# SOUTH OF KERN RIVER GROUNDWATER SUSTAINABILITY PLAN PUBLIC WORKSHOP #1

7 JUNE 2022

# DWR DETERMINATION LETTER – DEFICIENCY #1

# DWR IDENTIFIED THREE MAIN DEFICIENCIES IN THE KERN SUBBASIN “PLAN”

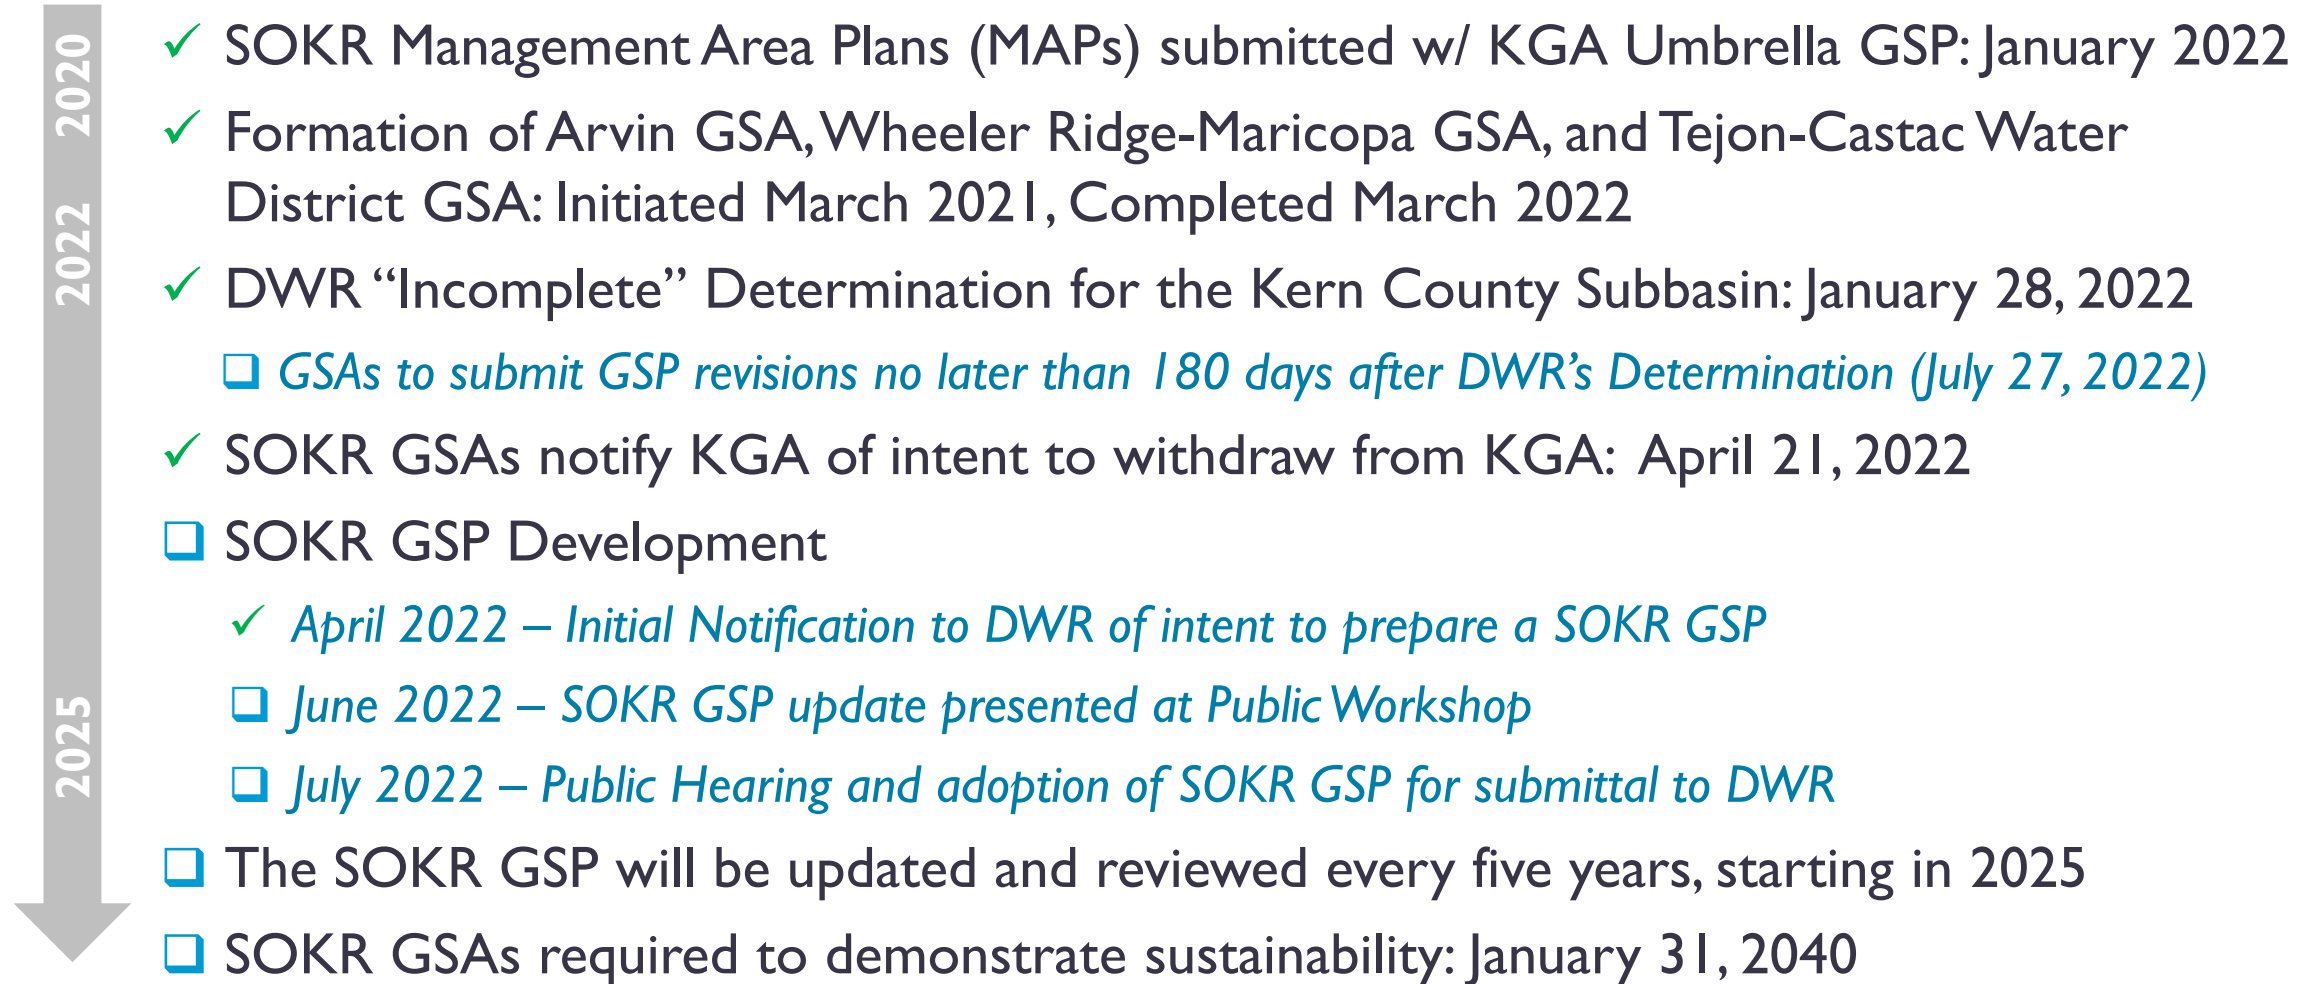
1. The GSPs do not establish Undesirable Results that are consistent for the entire Subbasin.
2. The Plan does not set Minimum Thresholds for Chronic Lowering of Groundwater Levels in a manner consistent with the requirements of SGMA and the GSP regulations.
3. The Plan’s Land Subsidence Sustainable Management Criteria do not satisfy the requirements of SGMA and the GSP regulations.
